DATE: February 24, 2017

SUBJECT: **Case 21123: Amended Substantive Site Plan Approval – 5504 Spring Garden Road, Halifax**

- Application by Westwood Developments Ltd. for changes to the approved building design for 5504 Spring Garden Road, Halifax
- May 9, 2013 approval by Design Review Committee of a Substantive Site Plan Approval for 5504 Spring Garden Road, Halifax (Case 18465)

5504 SPRING GARDEN
ROOF AREA COVERAGE
 1/16" = 1'-0"

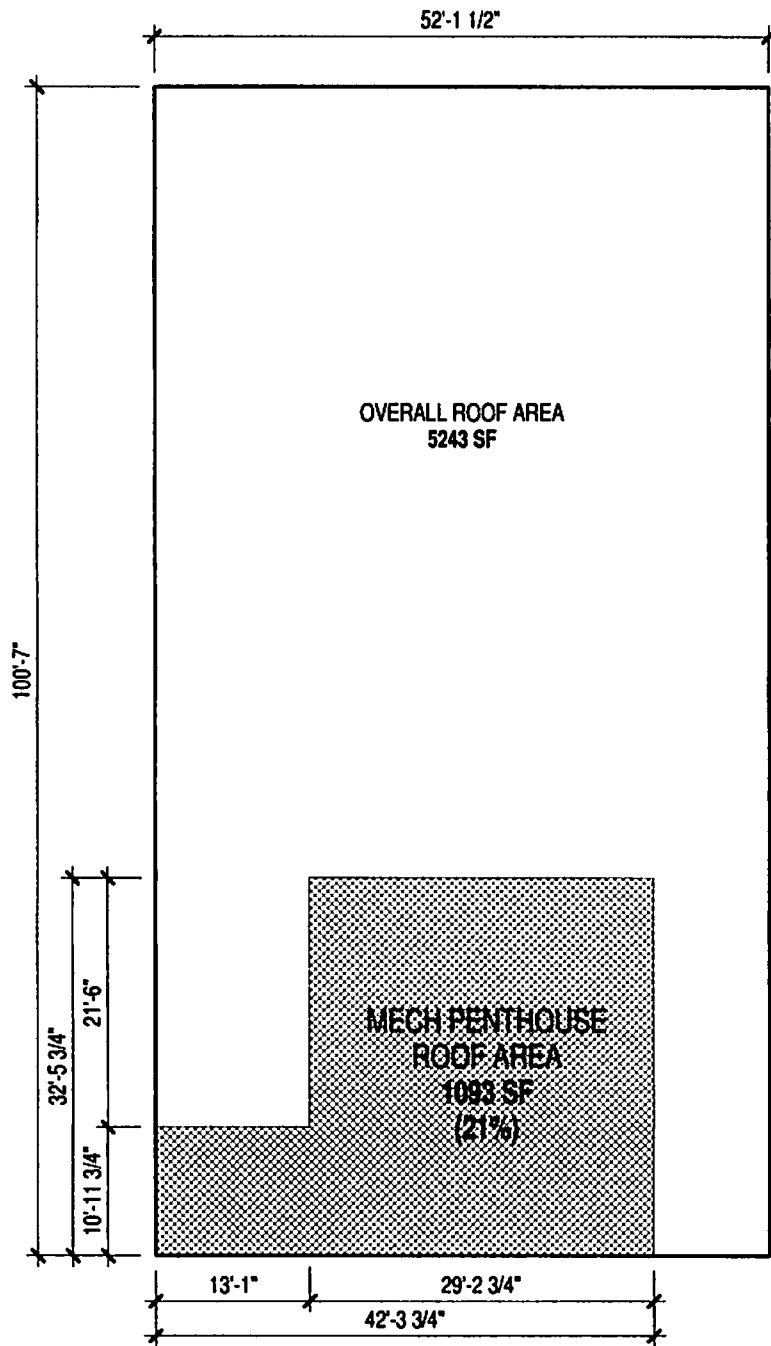
RE: Mechanical Penthouse — please provide a plan with measurements to confirm that the mechanical penthouse does not exceed 30% of the roof. Also, the flat roof portions of the roof are required to be landscaped in accordance with the land use by law.

The building is in compliance with HRM's Land Use By-law regarding maximum area for roof top penthouses and landscaped roofs. The attached sketch confirms the mechanical penthouse coverage is 21% of the roof area. We confirm the flat roof portions of the project are to be landscaped roof with a variety of plantings and pavers. Refer to Document No. 3.

East Elevation As Built Version

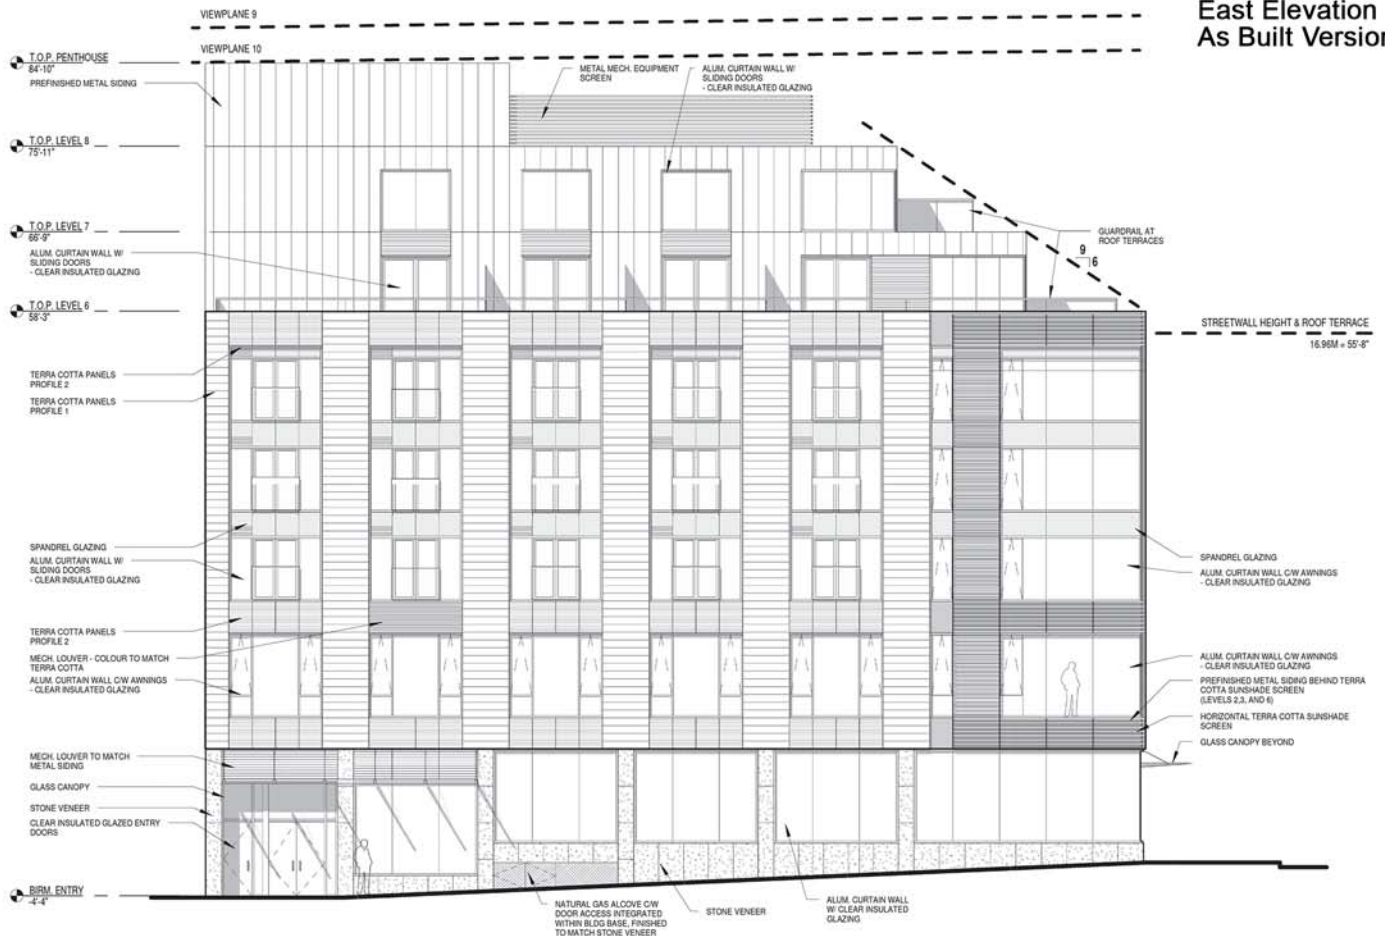
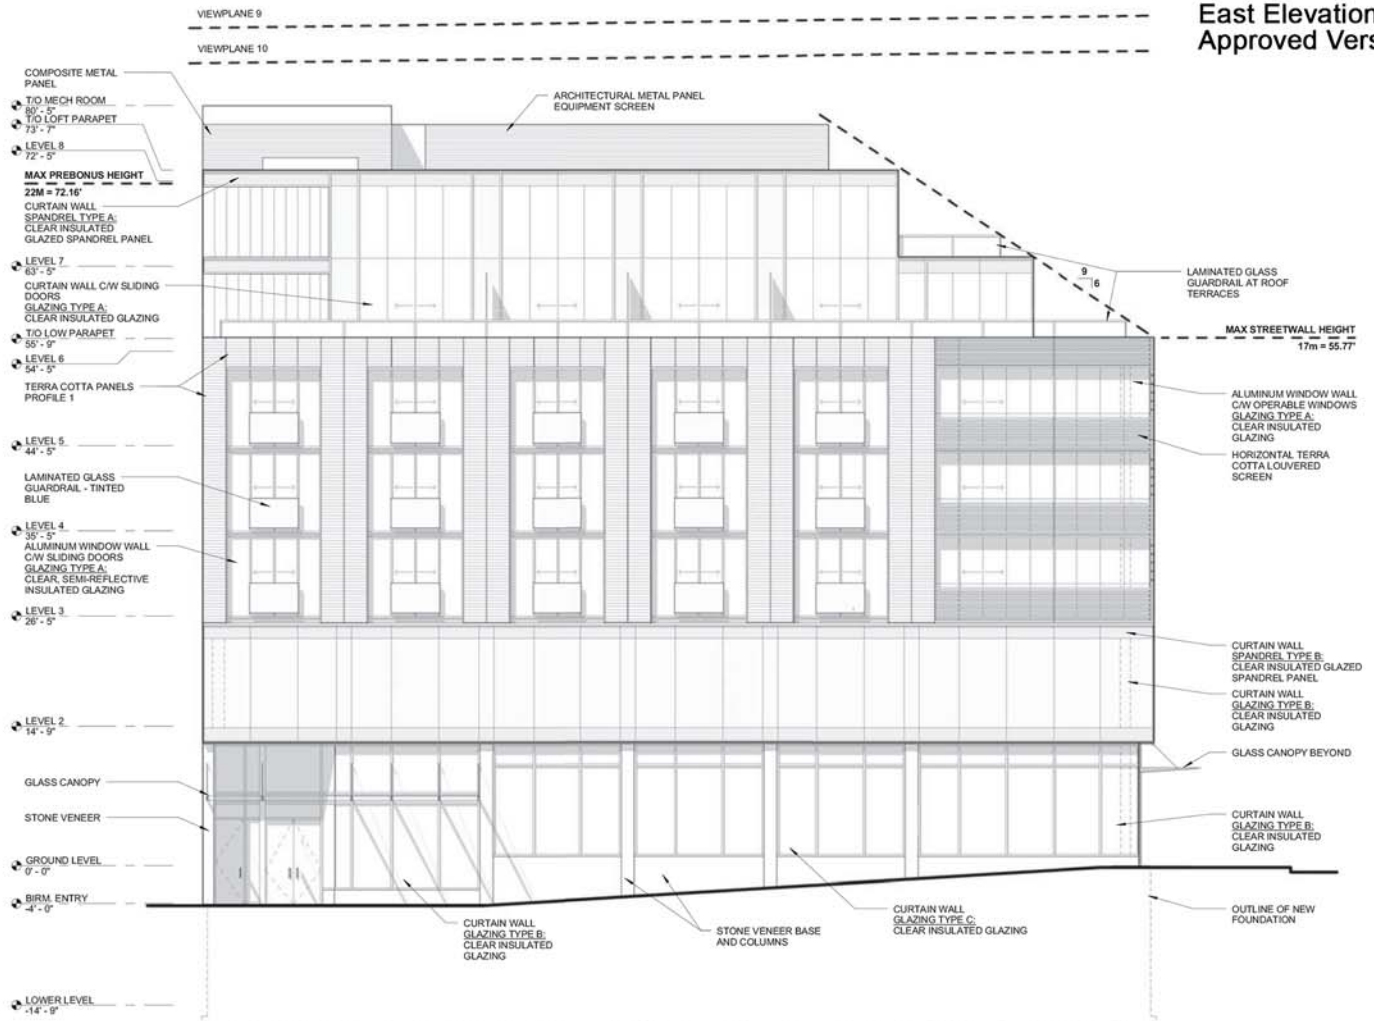
The rear wall of the building is constructed to the property line of the vacant abutting lot on Birmingham Street. The Design Manual discourages blank walls, and the approved design utilized a variety of colours and textures of terra cotta panels to achieve this goal. The rear wall was instead finished in white metal panels with relief lines. The applicant explains that the approved design would have been costly, and that future construction on the adjoining empty lot will eventually hide the wall, leading to the decision to make the change. This change conforms with the Design Manual and requires a new approval which is recommended by staff.

The Design Manual calls for the articulation of building facades by distinguishing the base, middle and top portions of buildings, providing a vertical rhythm which is in keeping with the character of narrow storefronts and by providing distinctive rooftops which contribute to the skyline. The building as-constructed does provide the three-part articulation, however the extra massing of the top that has resulted from the increased size and change in the finishing materials of the mechanical penthouse, makes the building appear top heavy. This is of particular concern given the corner location of the building and the emphasis the Design Manual places on good design for such sites.

To address this concern for the massing of the top floors of the building, staff suggest alternative materials be installed on the street facing facades such as glass curtain wall and spandrel panels as originally approved. This material change will provide a more transparent appearance and has been suggested in discussions to date, however the applicant has indicated that they do not wish to make any changes to the building as constructed.

Roof Landscape Plan As Built Version

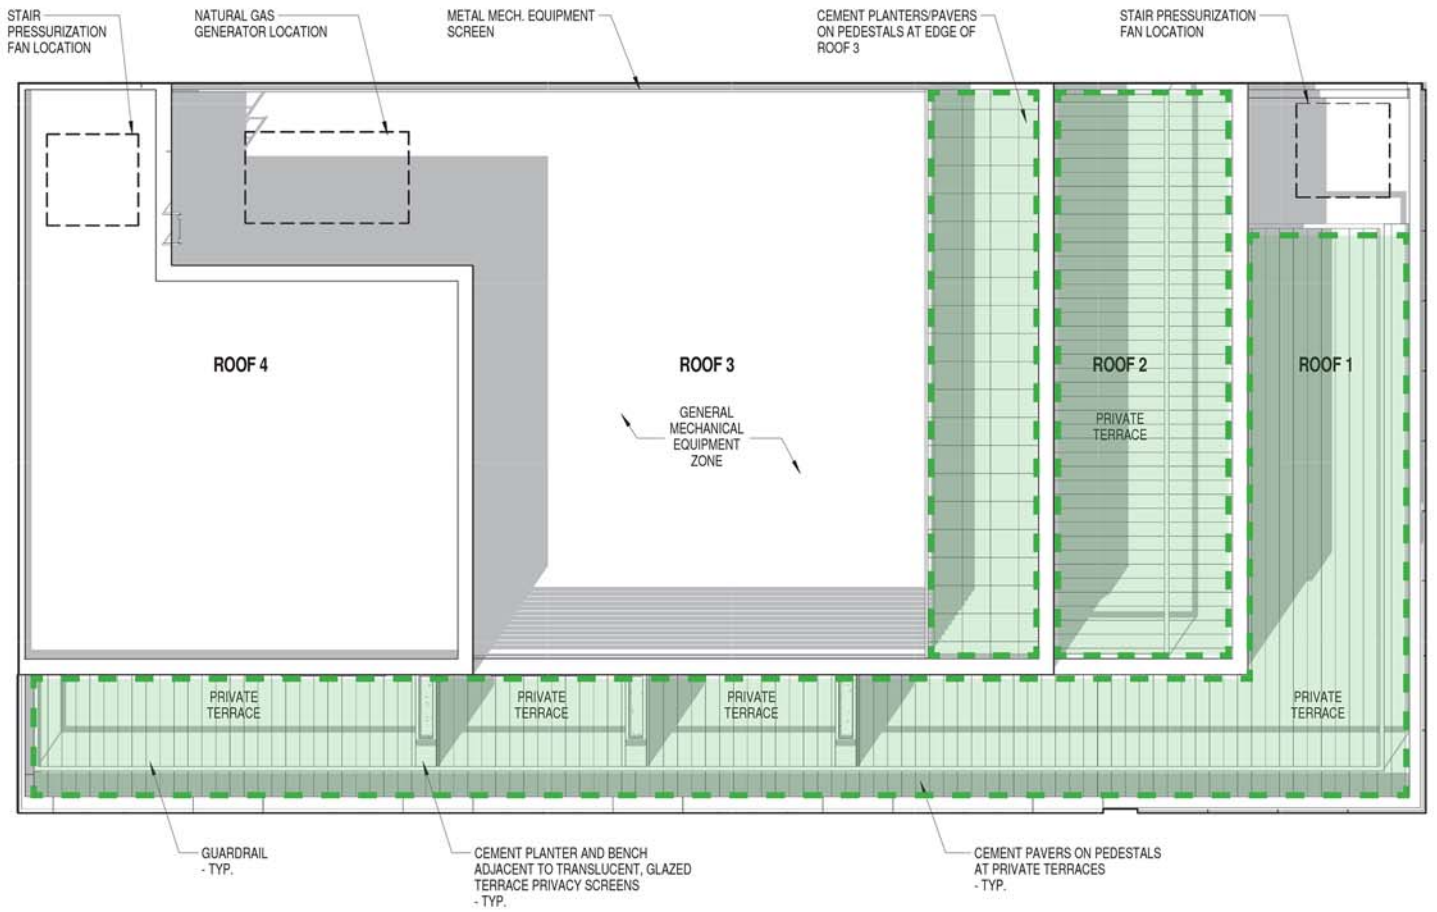
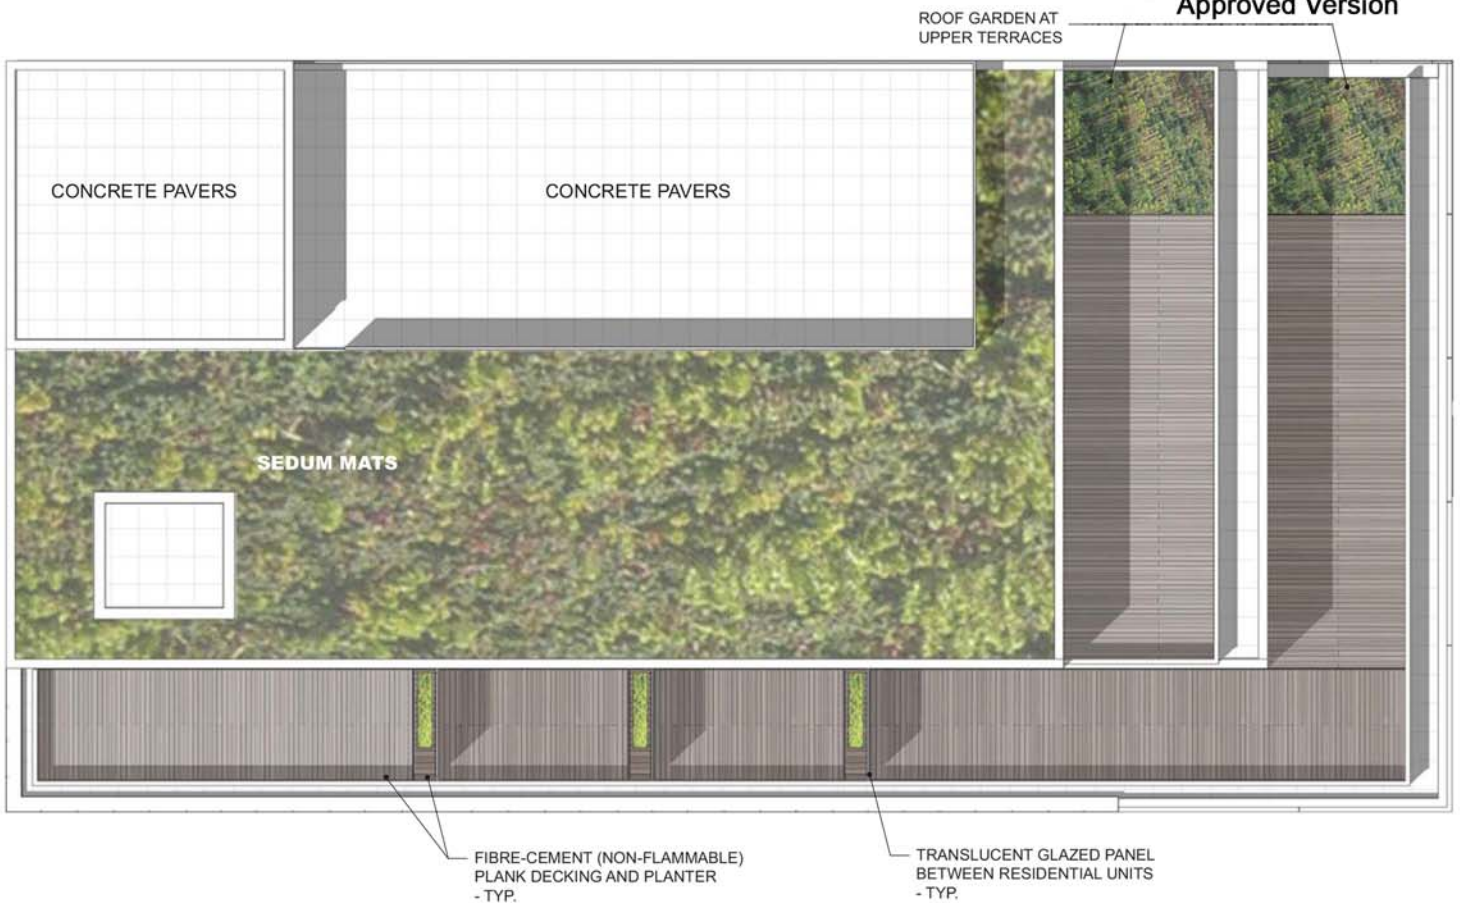
The Design Manual in section 3.3.4 (c) requires landscape treatments of all flat roofs in order to reduce the visual prominence of these landscaped areas; the use of 'green roofs' is strongly encouraged. The Design Manual emphasises that this is particularly important in the precincts close to Citadel Hill, which includes the subject site. The LUB defines landscaped open space as "...any combination of trees, shrubs, flowers, grass or other horticultural elements, decorative stonework, pavers, screening or other landscape architectural elements...".

The approved plans for the project included sedum mat planting on the roof of the 7th floor that met by-law requirements. The developer advises that the plantings were not provided as the mechanical penthouse and amount of rooftop equipment needed to be substantially increased, leaving little space for such plantings on a small site. Concrete paving slabs were instead provided to cover the roofing material, however, this is not acceptable as a single landscaping material. The landscaping requirement cannot be varied and landscaping must be provided to the greatest possible extent. Given the small footprint of the building and extent of rooftop mechanical equipment, most of the landscaping would have to be provided on top of the mechanical penthouse. There is space available both around the mechanical equipment and on the roof of the mechanical penthouse for landscaping to be installed.
